MIL-C-83421B
AMENDMENT 2
4 June 1993
SUPERSEDING
AMENDMENT 1
29 October 1991

CAPACITORS, FIXED, METALLIZED, PLASTIC FILM DIELECTRIC,
(DC, AC, OR DC AND AC), HERMETICALLY SEALED IN METAL OR CERAMIC CASES,
ESTABLISHED RELIABILITY,
GENERAL SPECIFICATION FOR

This amendment forms a part of MIL-C-83421B, dated 31 January 1991, and is approved for use by all Departments and Agencies of the Department of Defense.

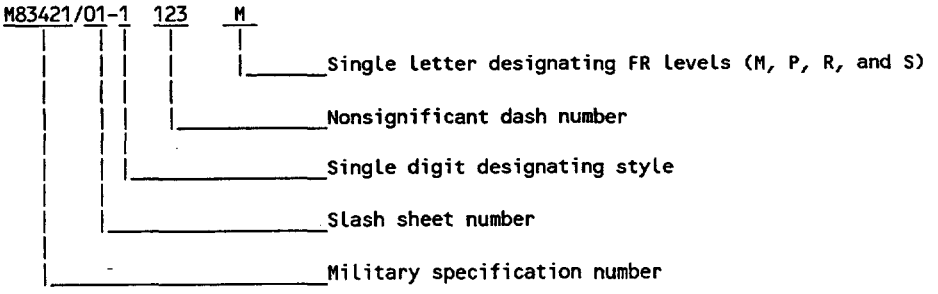
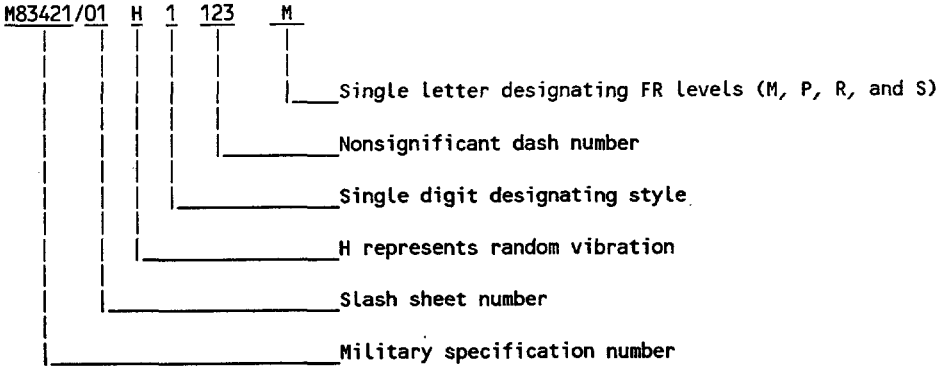
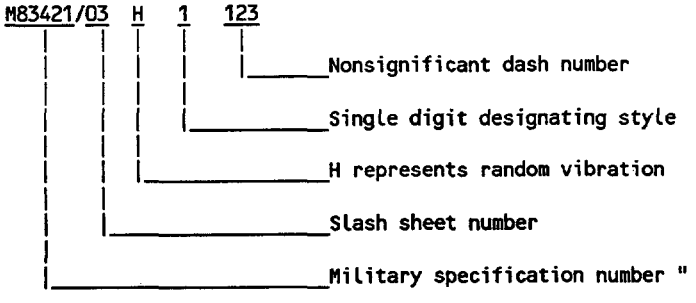
* 4.7.16d, delete and substitute:

"d. Measurements during and after shock: During the test, a cathode-ray oscilloscope (or other comparable means) shall be used as an indicating device in determining any electrical failures and intermittent contacts of 0.5 ms or greater duration, or open- or short-circuiting. Dissipation factor shall be measured as specified in 4.7.9 and shall be within initial limits. After the test, capacitors shall be visually inspected for evidence of breakdown, arcing, fractures, and other visible mechanical damage."
